From:
To:
Subject: FW: DA2021/ 1522: Key Points
Date: Wednesday, 2 February 2022 1:36:01 PM
Attachments: [image002.png](#)
[image.png](#)
[Assessment Report 20 Jan 2022.pdf](#)
[NBC Panel Advice Letter 25Jan2022.pdf](#)
[Assessment Report 01Feb2022.pdf](#)

Subject: DA2021/ 1522: Key Points

Description:	New - Demolition works and construction of a dwelling house
Application Type:	Development Application
Status:	Notified
Submitted:	30/08/2021
Notification Period:	02/12/2021 to 16/12/2021
Cost of Work:	\$ 2,725,000
Officer:	Adam Mitchell
Submissions:	Make a submission

Required tree root investigation location for Tree No. 13.

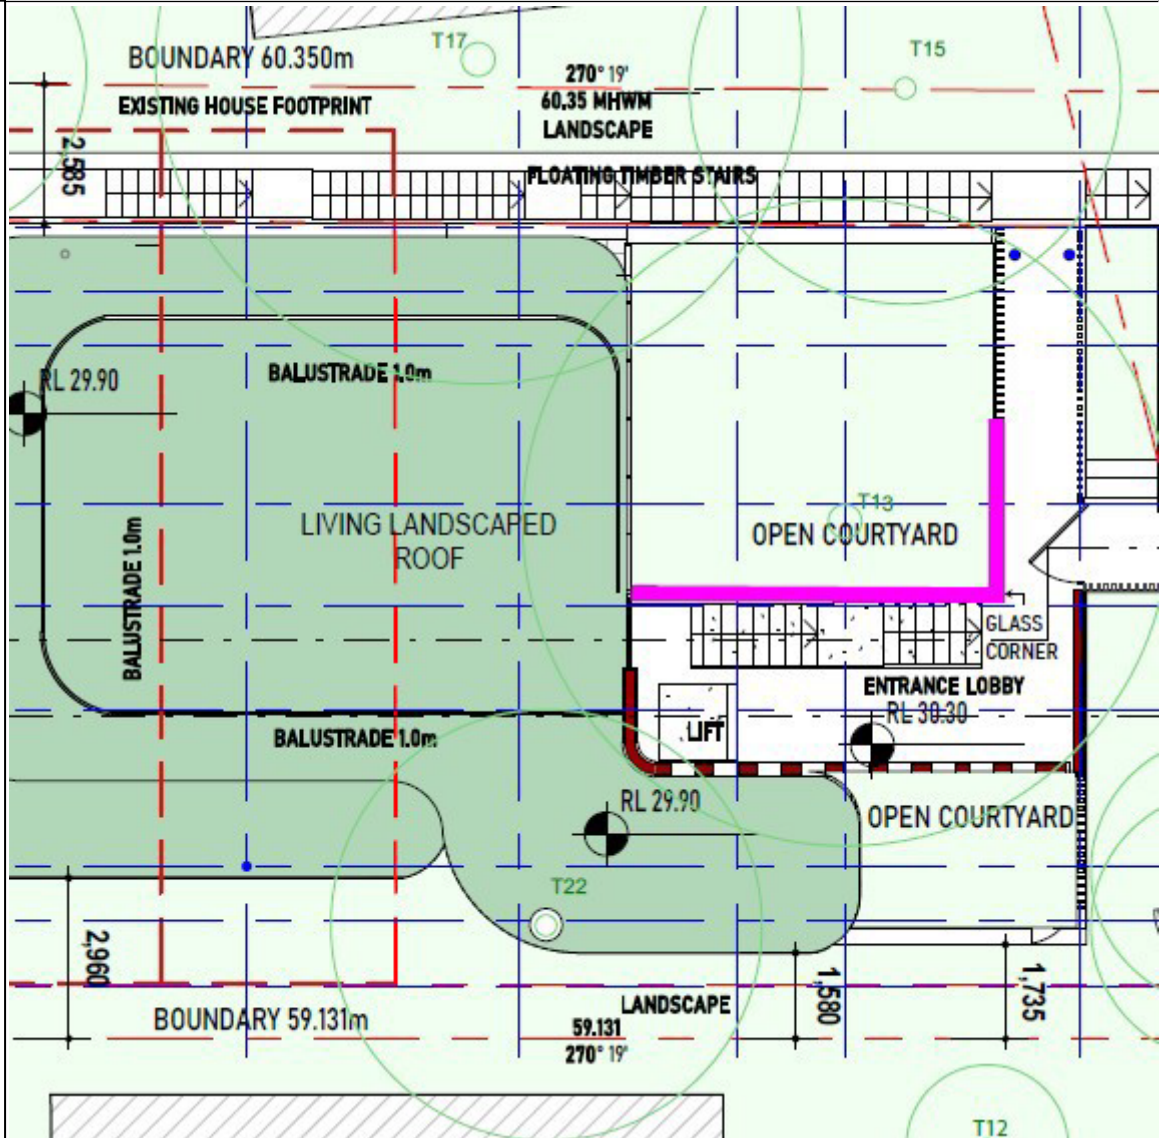
It is noted tree root investigations have taken place adjacent to Trees No. 13 and 27; how completed on the edge of proposed works. Hence, these investigations do not provide an proposed works. In order to ensure proposed works do not impact significant roots of the the locations as depicted by the PINK line in the below images. Should design alterations should take place on the edge of the proposed works, similar to that depicted in the belo

In light of the above concerns, the landscape component is therefore not currently supported detailing the likely impacts of proposed works on Trees No. 4, 5, 7 and 8, with successfully retained and adequately protected. Should this investigation find proposed tree root investigations are required in accordance with AS4970-2009, specifically Clause 4.2.1, a layout be sought ensuring that proposed buildings are located at least 2 metres from tree roots. Additional tree root investigations are required to take place in the locations depicted in the plan to determine no significant roots are found and no detrimental impacts on these trees is likely of consent.

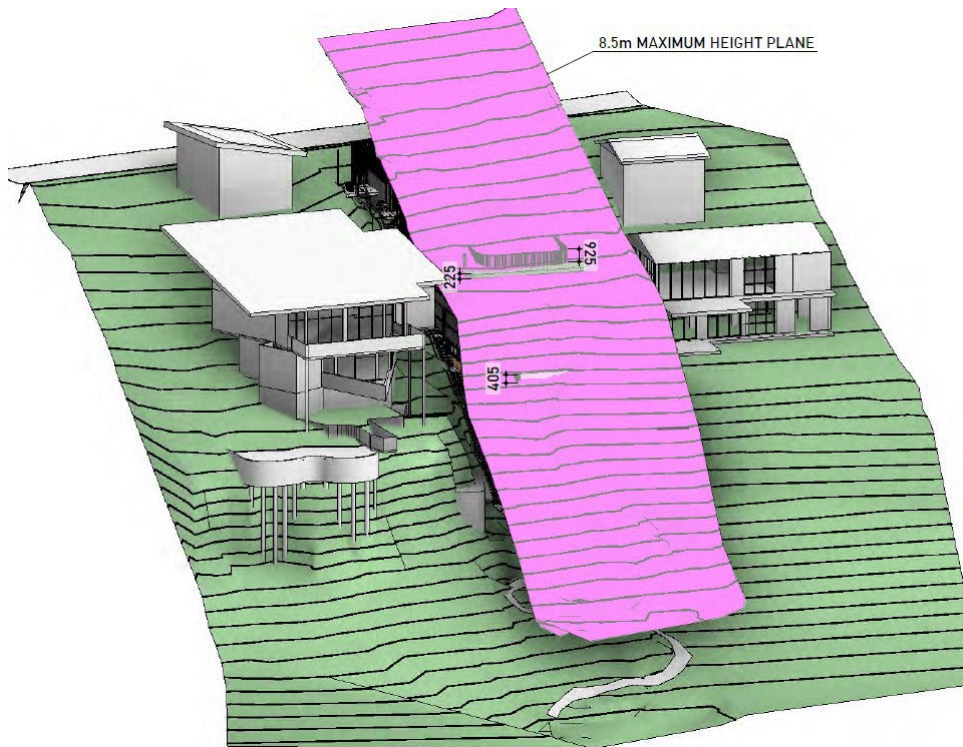
The project architect has prepared the below height blanket diagram taken at a height of 8.5m above ground level:

The extent of encroachment and the elements encroaching the 'blanket' in pink above are the elements subject of the below assessment, and those elements are considered to be minor.

D1.11 Building envelope

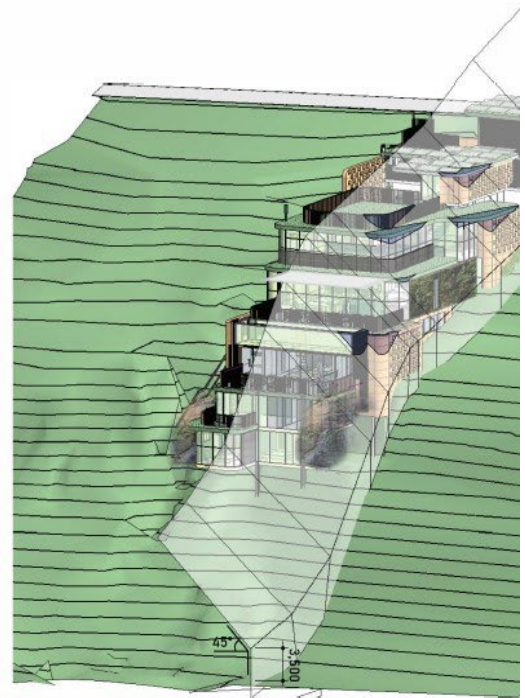
Clause D1.11 Building envelope of the P 21 DCP prescribes a 3.5m high envelope measured from the outer edges of the site before turning inwards at a 45 degree angle. Elements of the building should not project beyond this theoretical envelope. The control does include a variation provision that states that where a building footprint is situated on a slope of 16.7 degrees, a variation may be considered on a merit basis.

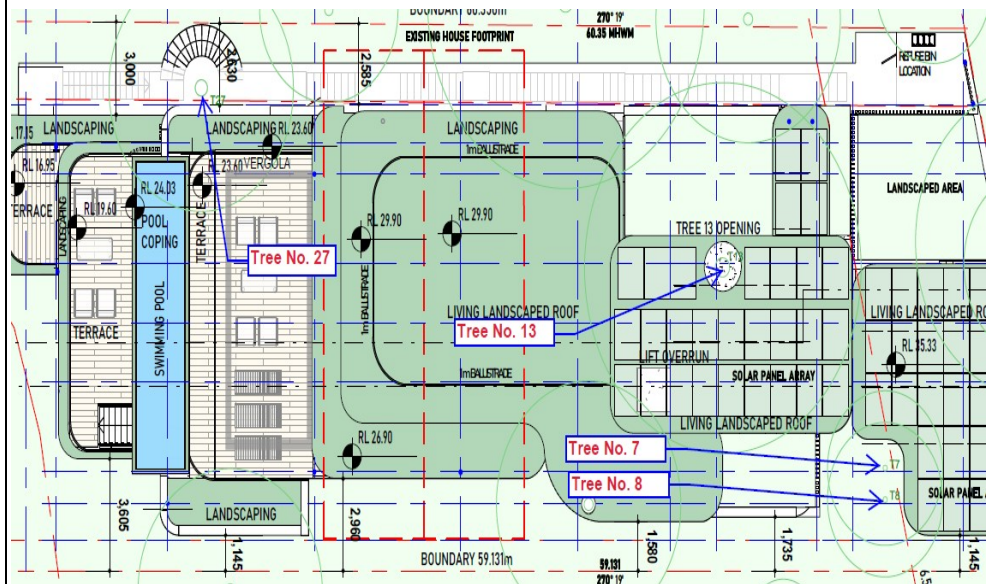
The two most significant trees located within the site, identified as Trees No. 13 and 27, have now been retained, with a number of tree root investigations taking place to determine the likely impacts of proposed works on existing root structures. Although this is seen as a positive, and it is clear work has been done to retain these trees, concern is still raised as these trees, in addition to Trees No. 7 and 8, fall within 2 metres of the proposed building. Should the plans be approved with the current layout, Trees No. 7, 8, 13 and 27 may all be removed without approval under the tree removal provisions outlined in control B4.22. The implications of this are significant as the total number of trees likely to be removed increases, including the two most value, biodiversity rich trees within the site. For this reason, it is recommended that further design alterations be made, ensuring that proposed works are at least 2 metres clear of proposed works to not only minimise impacts but also ensure they are retained in the long-term. The proximity of these trees to the proposed building can be seen in the image below:

Required tree root investigation location for Tree No. 13.

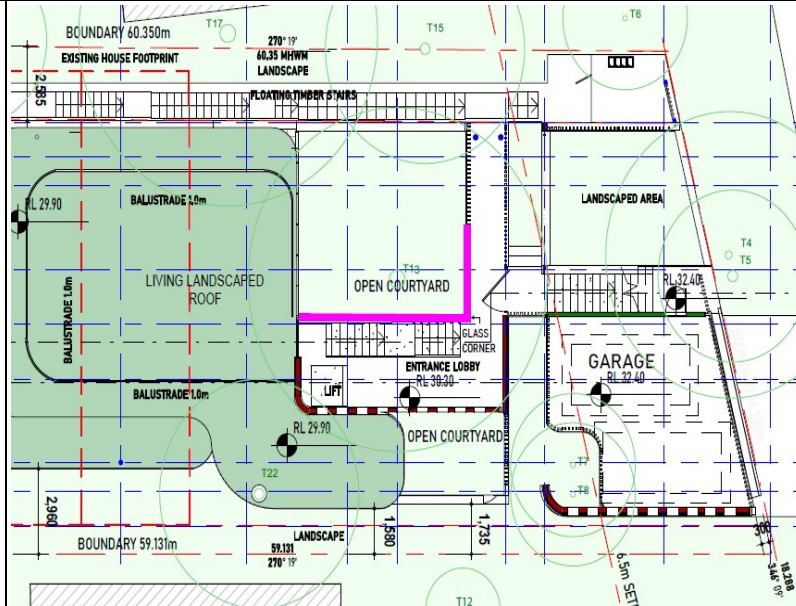
It is noted tree root investigations have taken place adjacent to Trees No. 13 and 27; however, concern is raised as these tree root investigations do not appear to have been completed on the edge of proposed works. Hence, these investigations do not provide an accurate depiction of the existing roots and what is likely to be impacted by the proposed works. In order to ensure proposed works do not impact significant roots of these two trees, it is recommended that additional tree root investigations take place in the locations as depicted by the PINK line in the below images. Should design alterations be made to ensure greater clearance from these trees, the tree root investigations should take place on the edge of the proposed works, similar to that depicted in the below images:

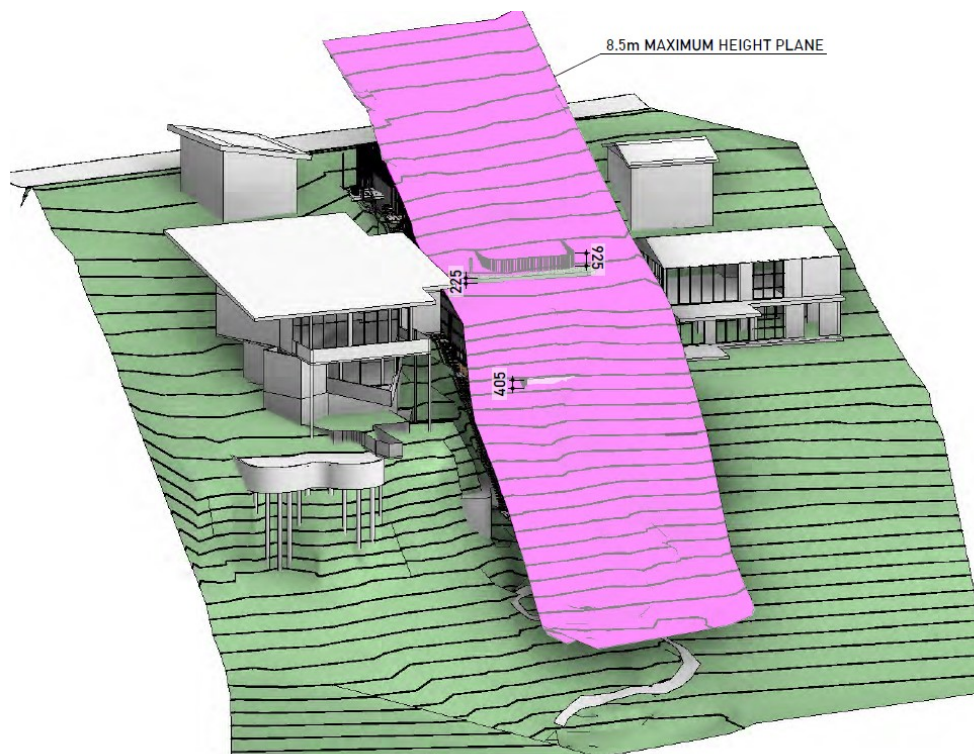
The project architect has prepared the below height blanket diagram taken at a height of 8.5m above ground level:

The extent of encroachment and the elements encroaching the 'blanket' in pink above are the elements subject of the below assessment, and those elements are considered to be minor.

NORTHERN ENVELOPE SETBACK SHOWN AT 3.5m HEIGHT AT 45°

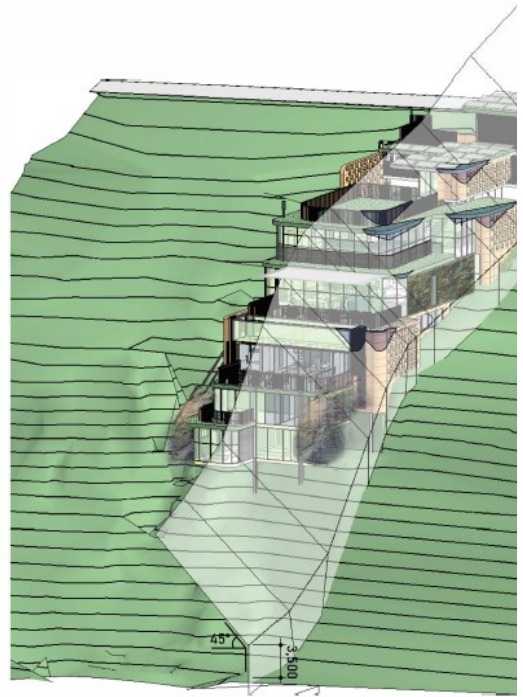
The proposal exceeds the prescribes envelope on both the northern and southern elevations as depicted on the below overlay plans prepared by the architect:
